Local Review Body

Planning Application for Review

**Erection of two 67m high to blade tip wind turbines:
Priestside Farm, Auchentiber Road, Kilmacolm (13/0036/IC)**

- Planning Application and plans
- Site photographs
- Report of Handling dated 18 April 2013
- Consultation Responses
- Representations
- Decision Notice dated 23 April 2013
- Letter dated 16 July 2013 from Bryce Boyd Planning Solutions enclosing Notice of Review form together with supporting documents
- Suggested conditions should planning permission be granted on review

LOOKING WEST
VIEW FROM WEST KILBRIDE
3 TURBINES WITHIN AN ARC
of 15°

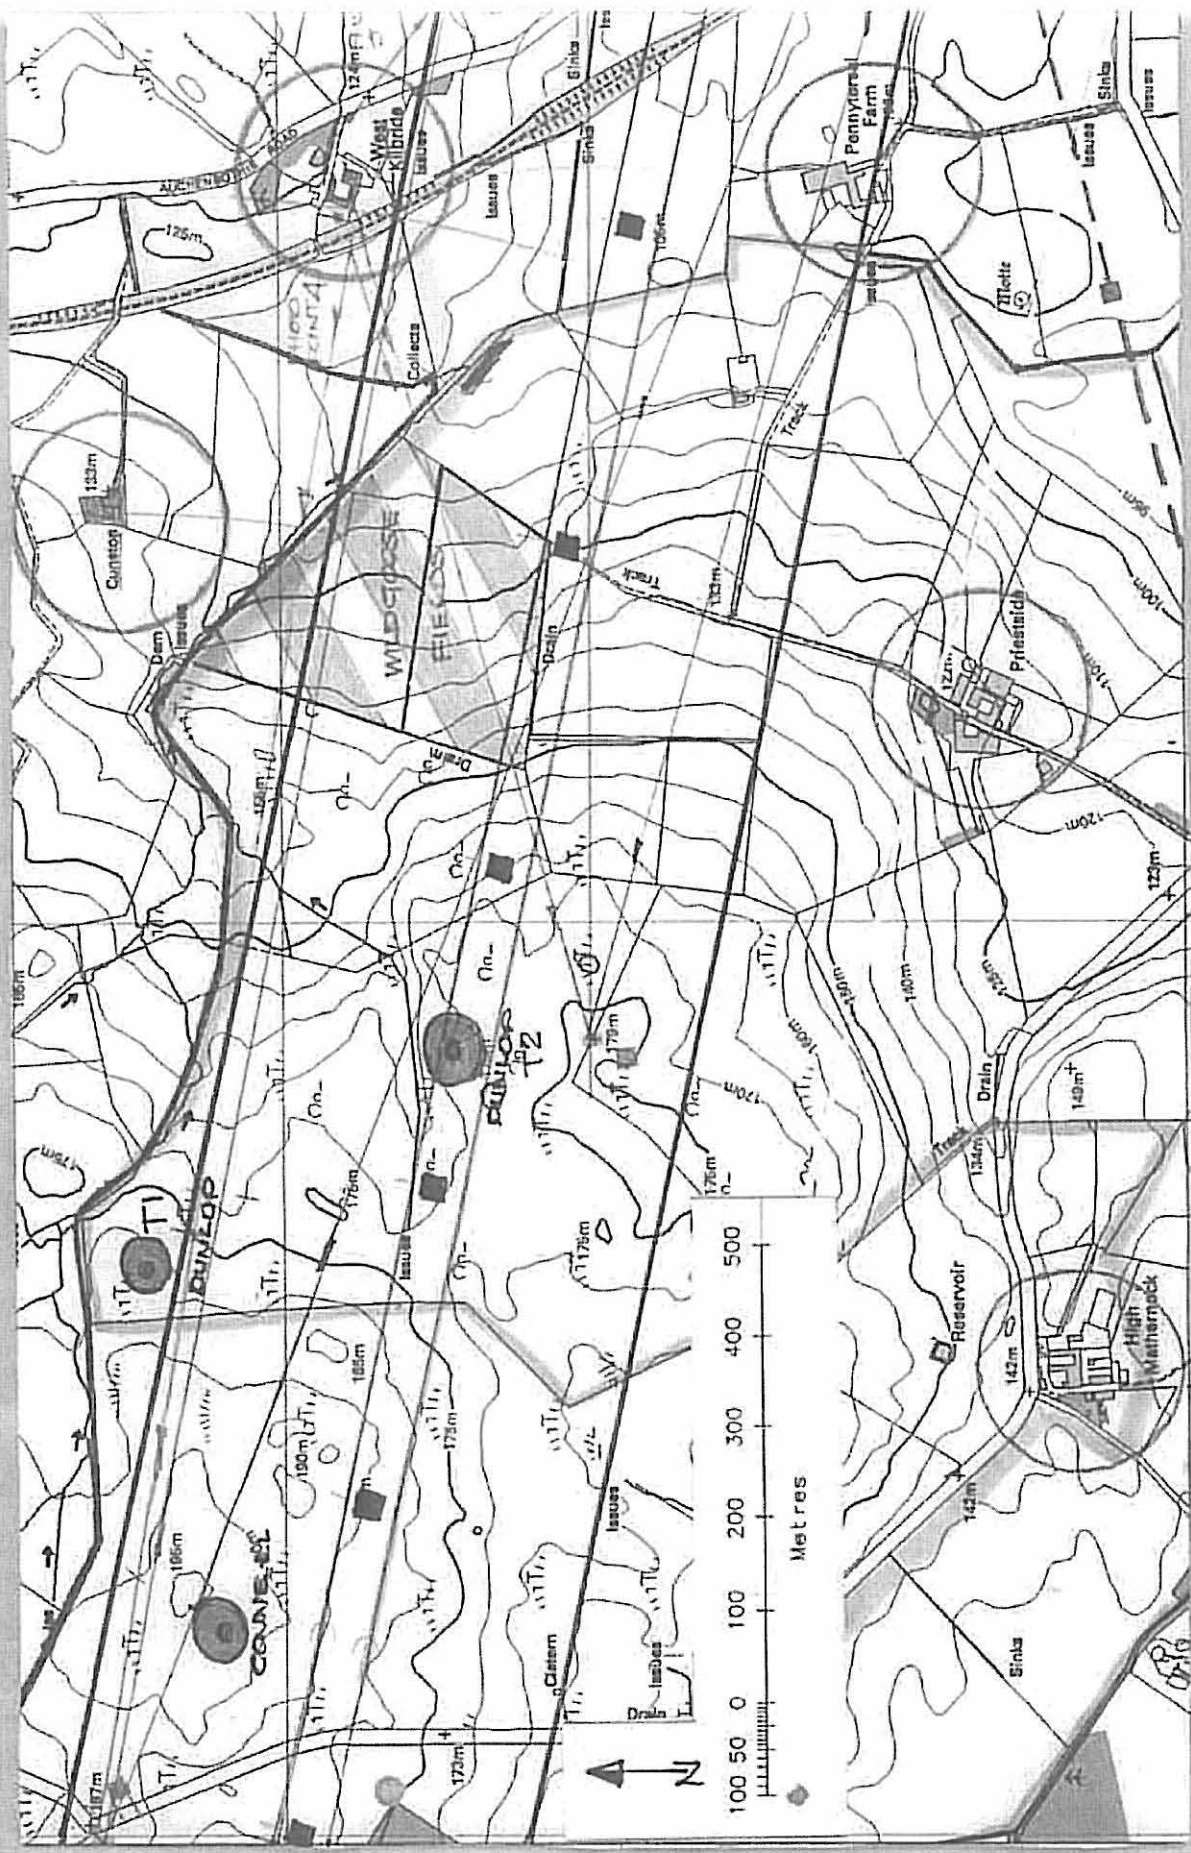
Para 6.26 West Kilbride will experience a **HIGH** magnitude of change. This is extremely concerning. The proposed turbines including the one at High Mathernock will dominate the skyline, and create noise and flicker which will be most disturbing. (see sketch 2)

The Proposal for two further 65m turbines is an unmitigated disaster for the residents of West Kilbride and Cunston Cottage. It has been noted that the Beveridge family has resided at West Kilbride for forty years; the Emerson Family of Cunston Cottage has resided there for several generations. It is strongly recommended that this proposal be refused.

PRIESTSIDE FARM
 L3 ZTV to 30km
 December 2012
DAVID WILSON ASSOCIATES
LANDSCAPE ARCHITECTS

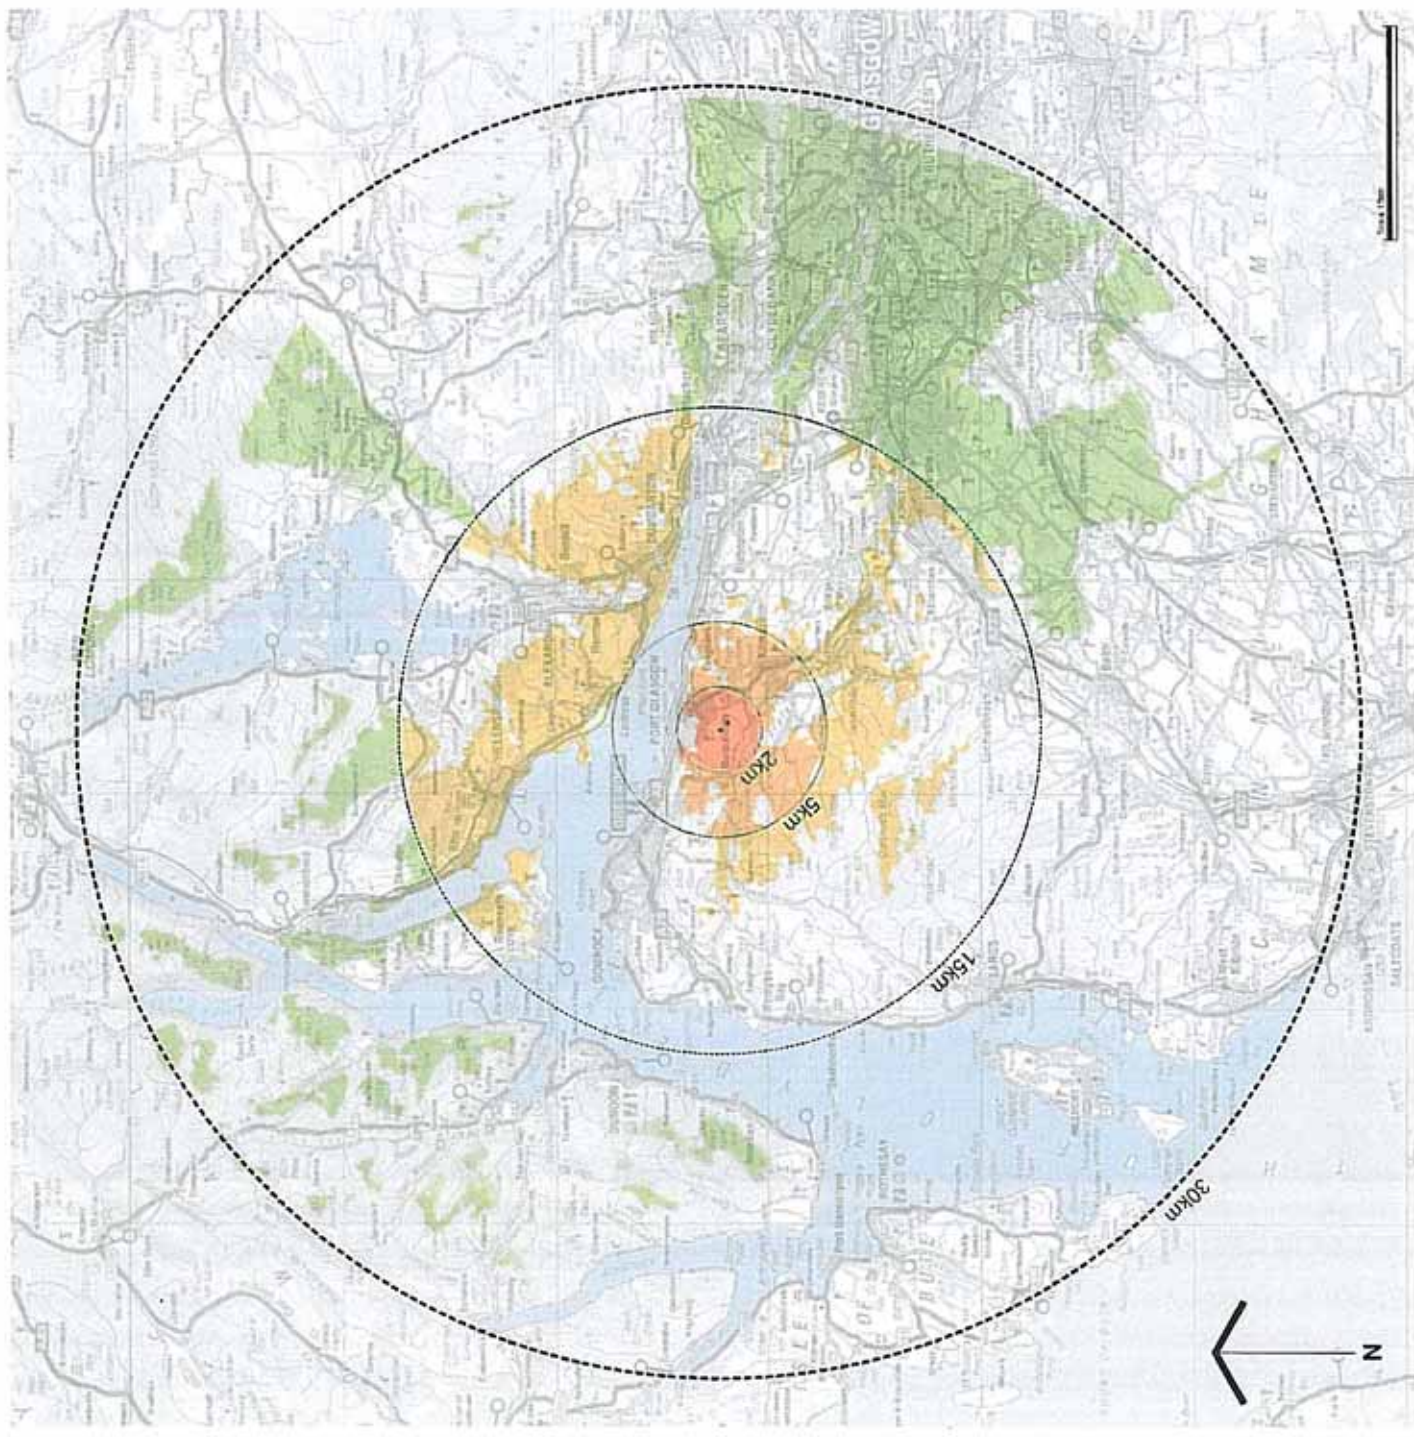
- 6.4 Drawing L3 shows the predicted theoretical visibility over a radius of 30km. It shows a theoretical visibility over much of Glasgow and the town of Paisley to the east. In reality such views will not be possible over this distance. The built form of these towns and all of the woodland, tree cover and structures in the landscape between these places will mean that virtually no views of the site over this distance will in fact be possible. In the event that any views are possible the distance from the turbine would mean that any impact would be negligible from a turbine of this height.

PRIESTSIDE FARM
 L5 CUMULATIVE IMPACT
 December 2012
DAVID WILSON ASSOCIATES
LANDSCAPE ARCHITECTS

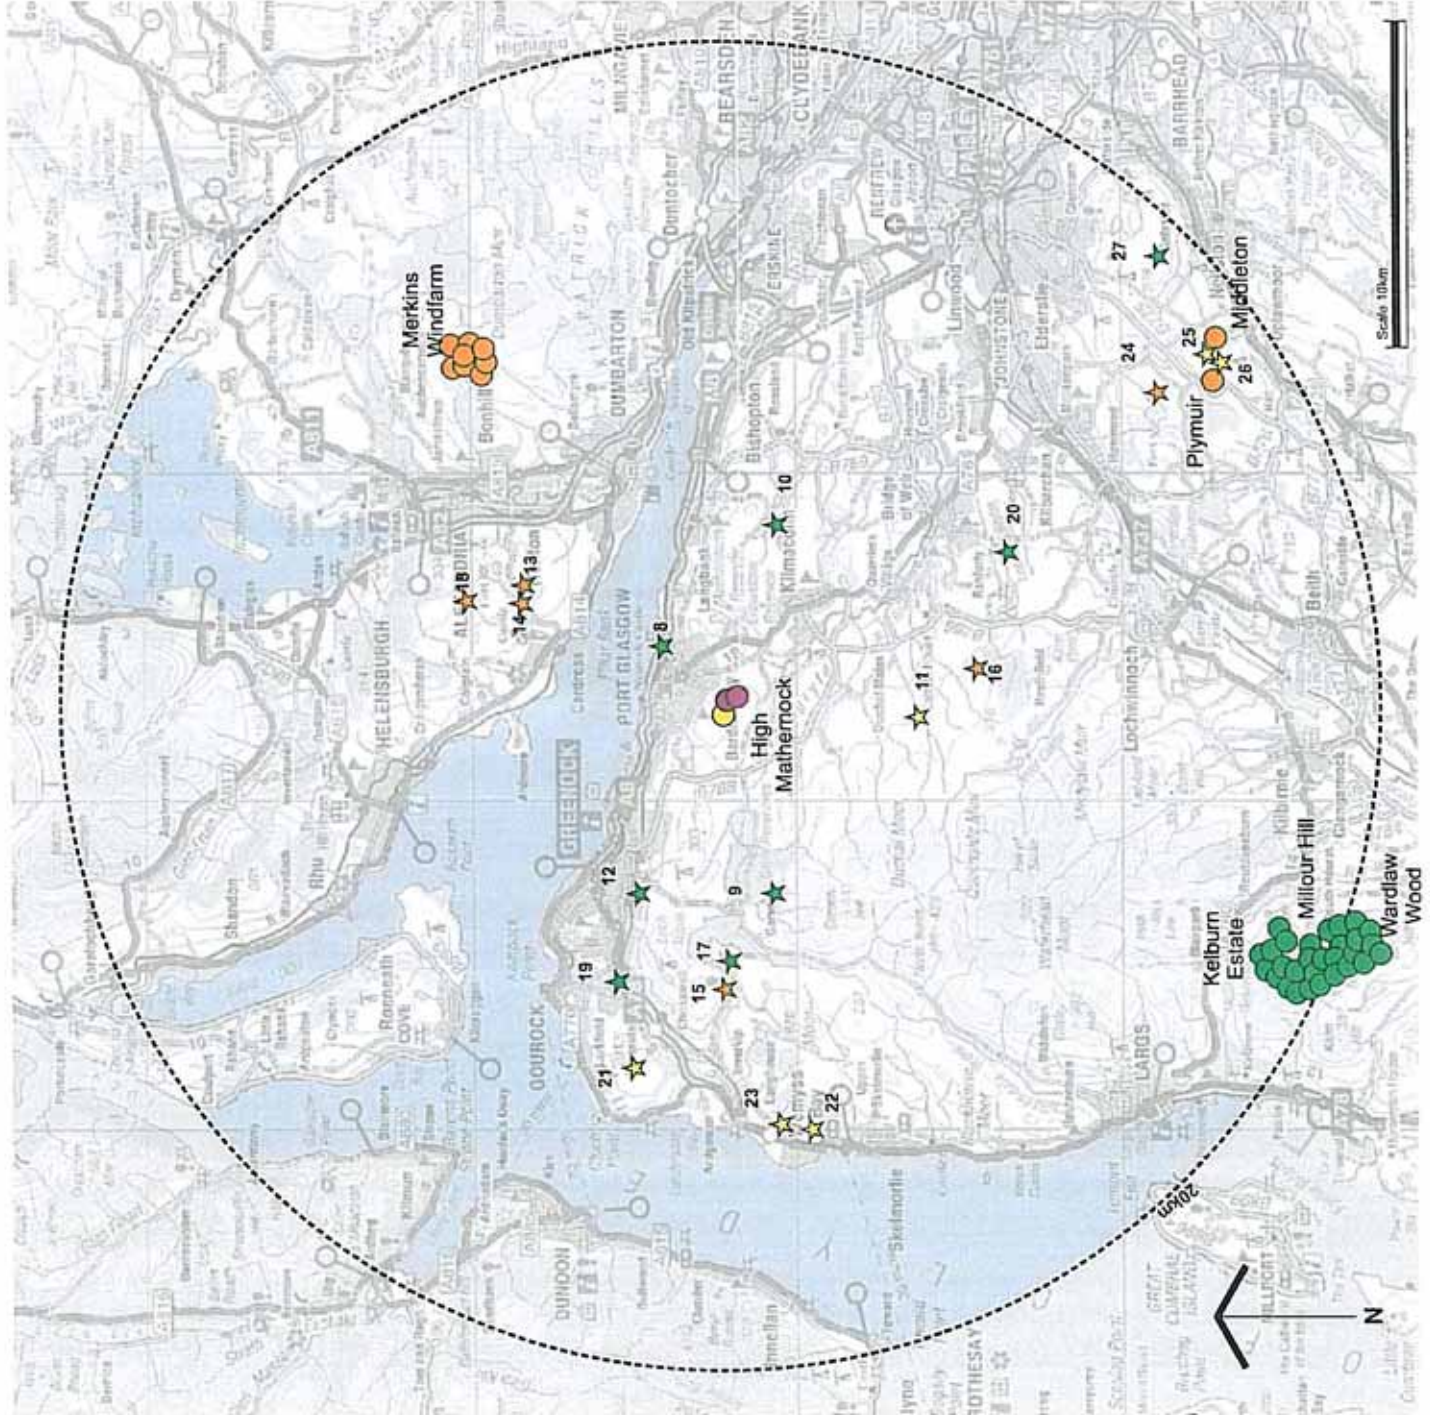
8.1 Drawing L5 shows the wind farm activity in the region over a 20km radius and the potential cumulative impact created by them. This is based on SNH's Windfarm Activity in Scotland plan published in August 2012. This information is a few months out of date but appears to be the latest version of the map available from SNH. These have been checked against the Inverclyde Council eplanning web portal in an attempt to ensure that the information is up to date however this is a fast moving situation and over the period of time it is likely that some of the applications will have advanced and others may have been proposed. Others may have been withdrawn or refused. This information is accurate as of December 2012.
